**RE: PROPOSED SENIOR LIVING DEVELOPMENT**  
**40A COPE STREET LANE COVE**  
**RESPONSE TO TRAFFIC MATTERS**

1. As requested, we have reviewed the traffic matters raised in the Council letters dated 26 April and 24 May 2023. The letter dated 26 April raised the following traffic matters:

Figure 1

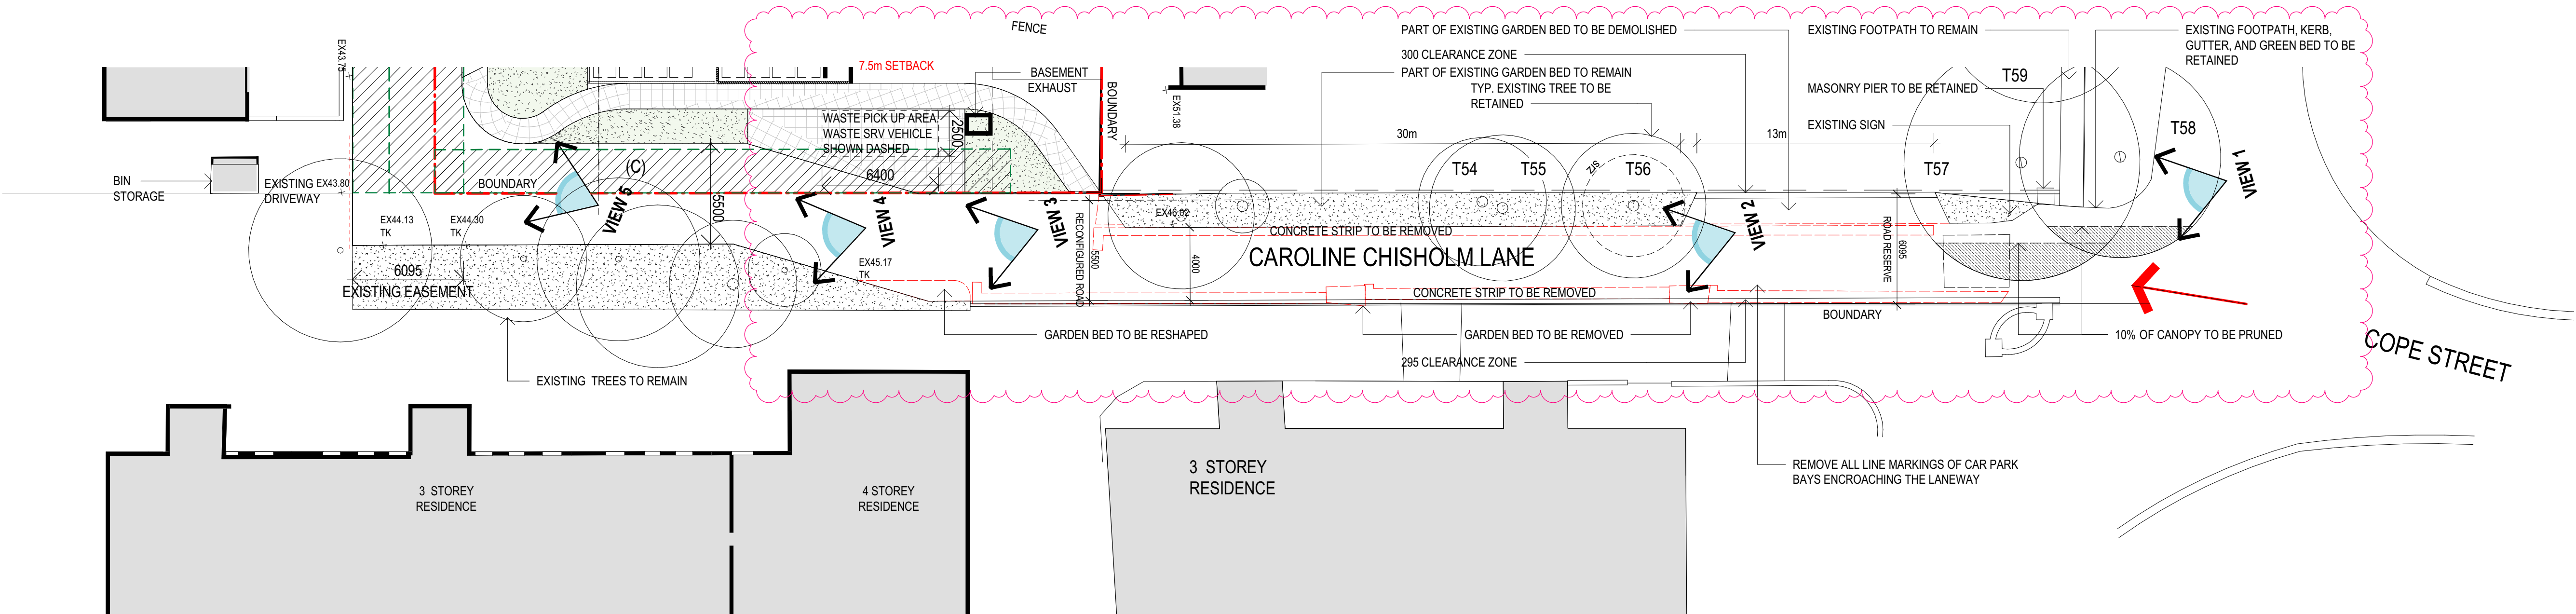
*Caroline Chisolm Lane should accommodate two-way traffic from Cope Street to the car park entry. Currently this lane has a maximum width of 5.5m (narrower in some sections). This would require widening of the lane to six metres for its full length, necessitating land acquisition from properties which are not part of the development. It is noted that the traffic report prepared by Colston Budd Rogers Kafes Pty Ltd assumes that Caroline Chisolm Lane is 6 metres wide and accommodates two-way traffic.*

*Further to the advice contained in Council's letter dated 26 April 2023, Council's Development Engineer – Traffic has requested that a 1.5 metre wide DDA compliant pedestrian access be provided along Caroline Chisholm Lane in addition to a minimum 6 metre wide roadway. As discussed, widening of Caroline Chisholm Lane is problematic, as the only way to achieve widening to 6 metres would be to*

*remove existing mature street trees. This is not supported by Council. It would appear that a DDA compliant pedestrian access along Caroline Chisholm Lane would not be achievable due to the constrained width of the Lane.*

7. Nonetheless, to improve traffic flow in Caroline Chisholm Lane, the applicant is prepared to undertake localised widening to provide two way traffic flow where possible. We understand that existing landscaping prevents widening of the full length of Caroline Chisholm Lane. On this basis the following works are proposed:

- a passing bay (13 metres long by 5.5 metres wide) at the northern end of Caroline Chisholm Lane; and
  - widening of the lane to some 5.5 metres for the last 35 metres (to the site access).

8. The above works are shown in Figure 1 and result in Caroline Chisholm Lane having a one lane section no longer than 30 metres with good sight lines. Vehicle swept paths are shown in Figure 2.

6.4m SMALL RIGID VEHICLE  
SWEPT PATHS

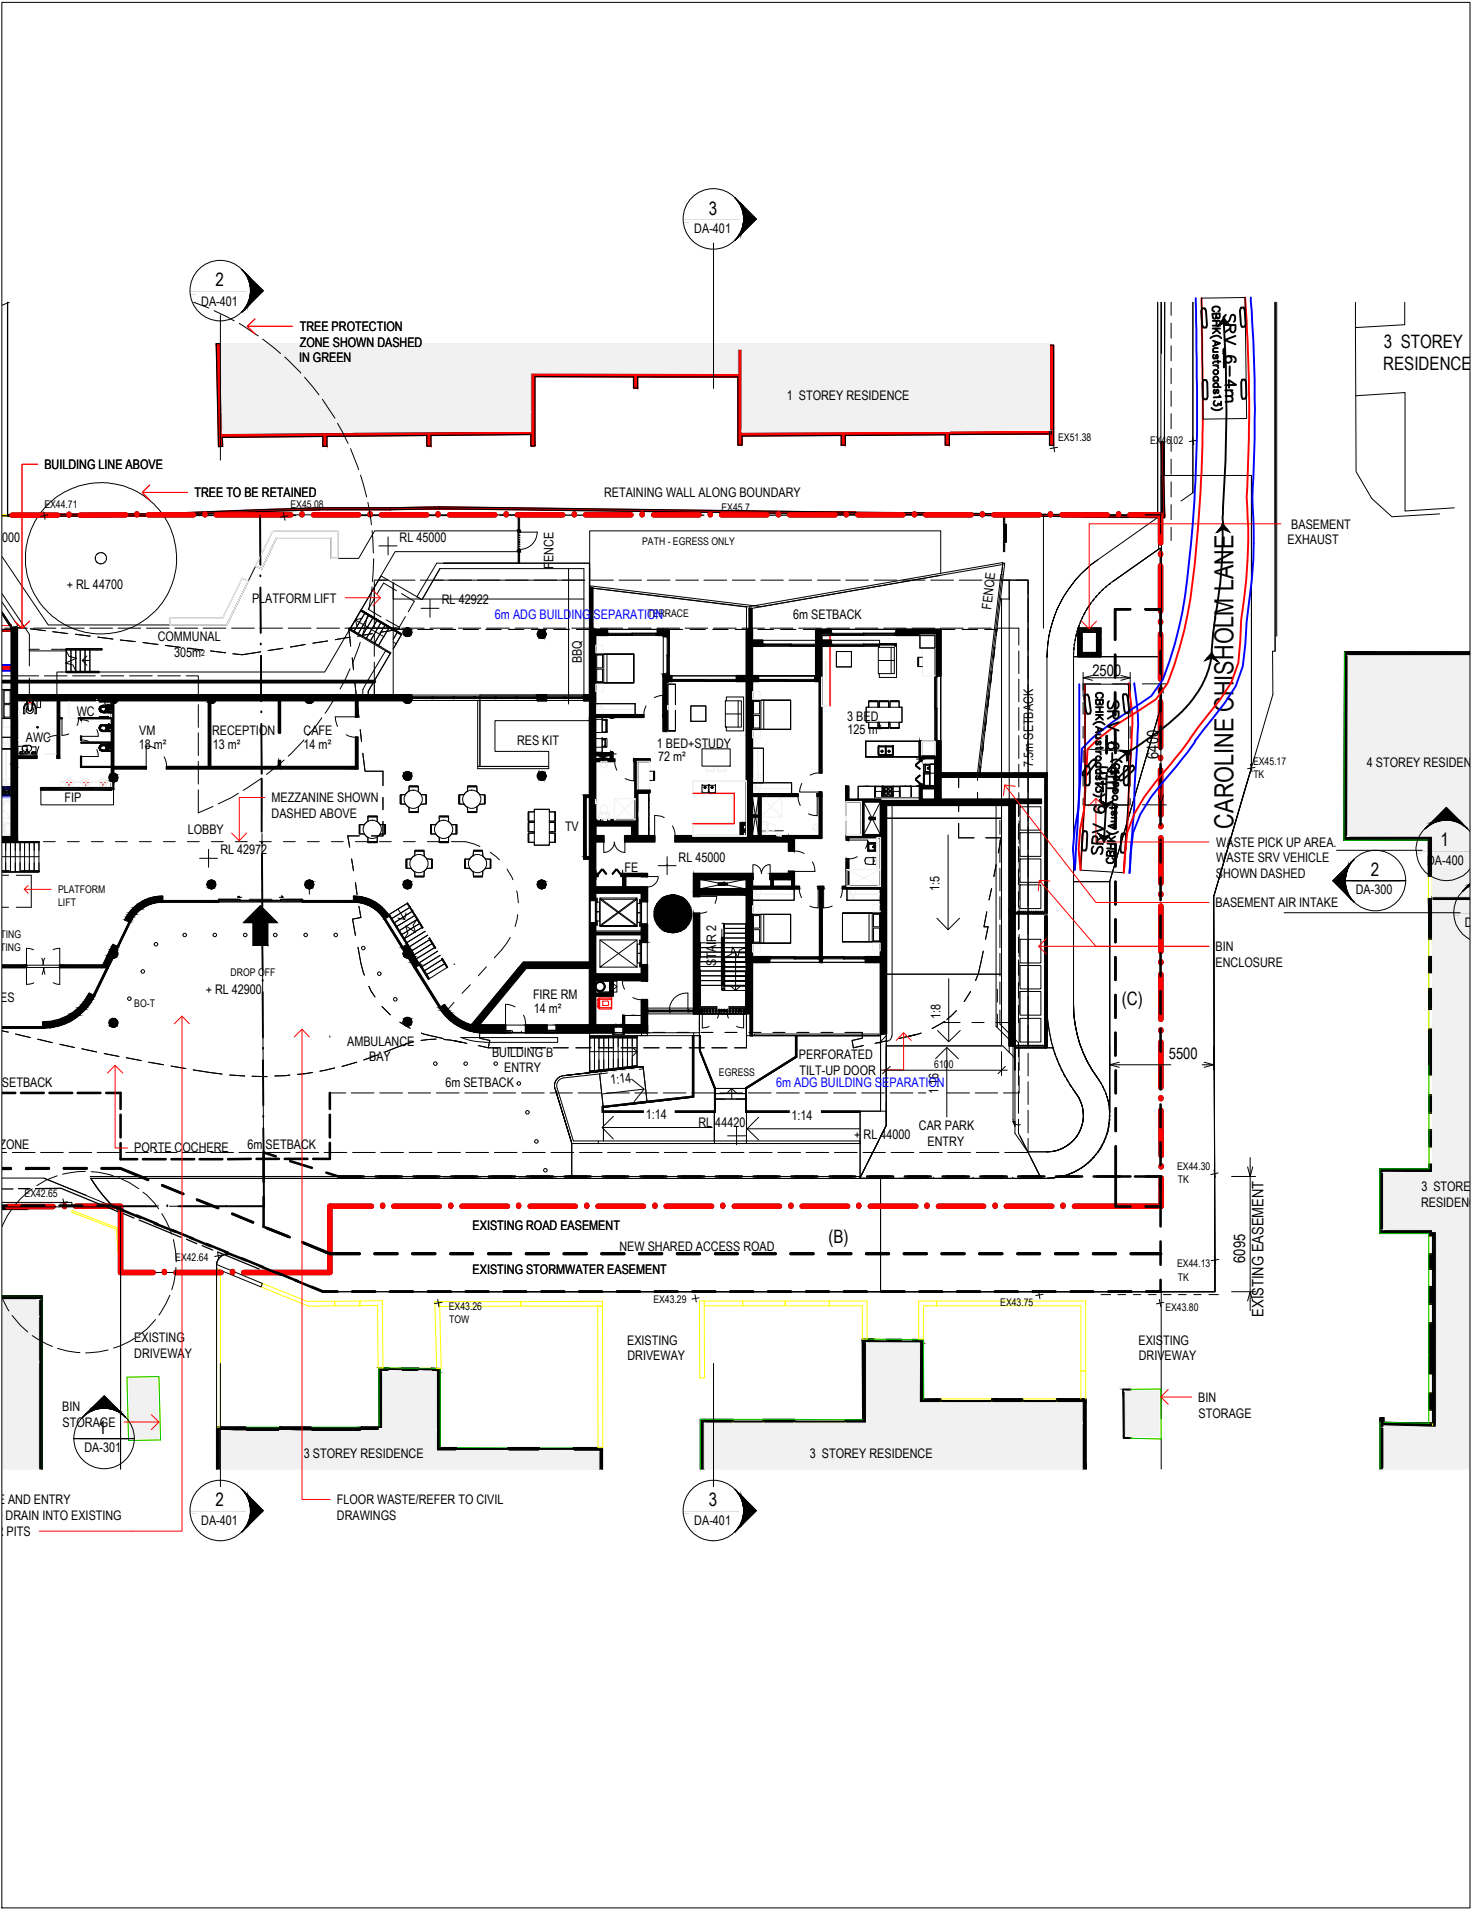
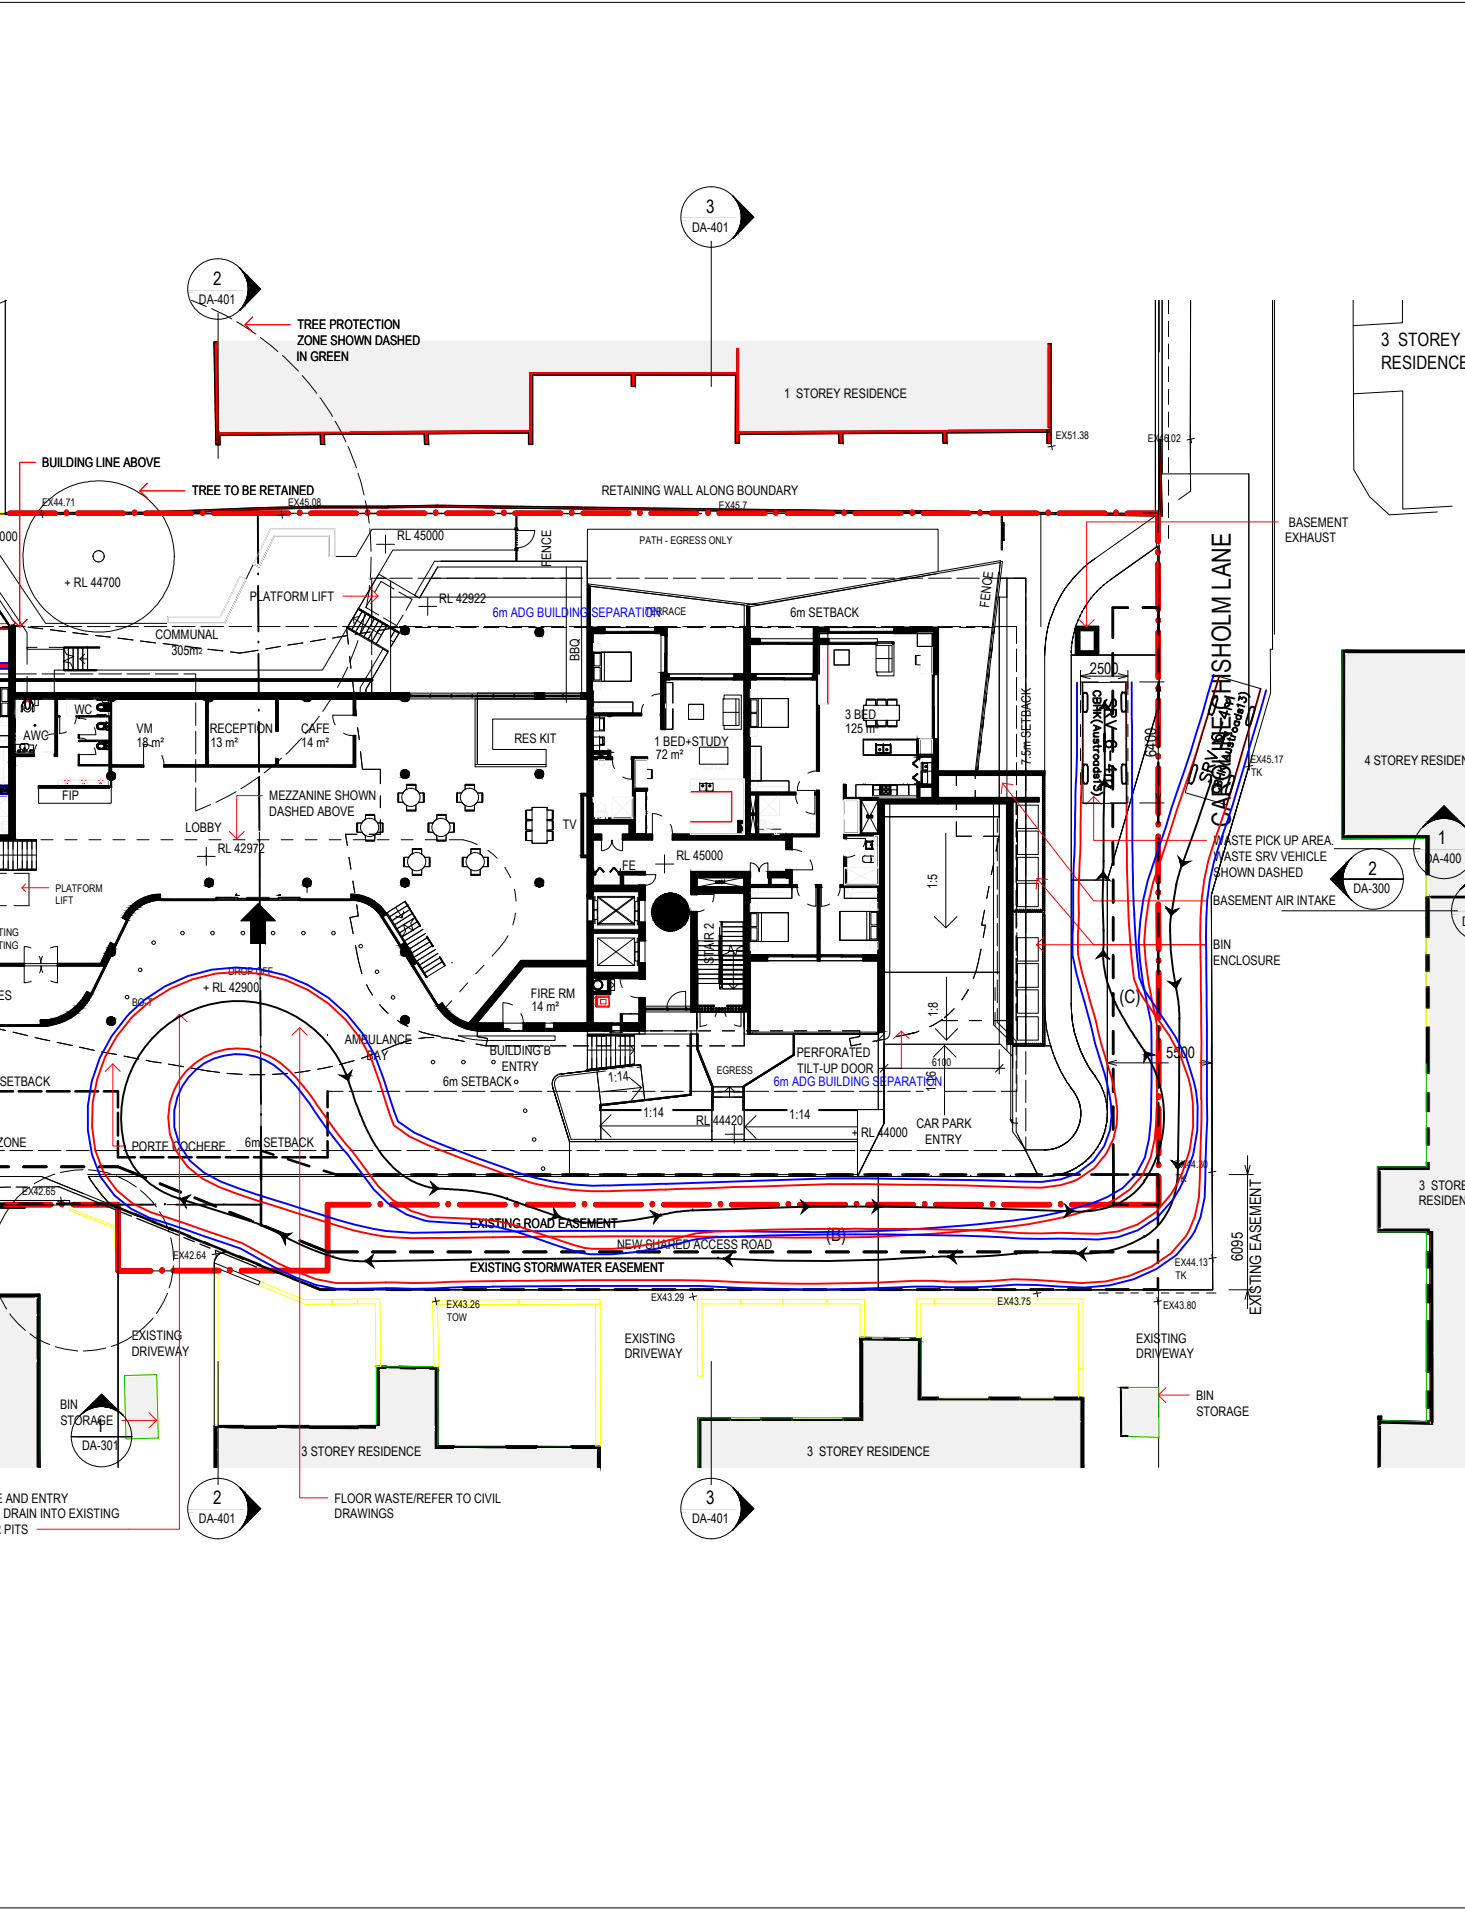
*It is noted that the area provided for waste pickup encroaches onto Caroline Chisolm Lane. This encroachment will be larger if the lane is widened to 6 metres. Additionally, the truck needs to be sitting flat when servicing, which will not be achievable when one wheel is on the lower road section.*

10. To address this matter, the design of the waste pick up area has been modified such that it does not encroach onto Caroline Chisholm Lane and that the truck is sitting flat when servicing. Updated swept paths are provided in Figure 3.
11. We trust the above provides the information you require Finally, if you should have any queries, please do not hesitate to contact us.
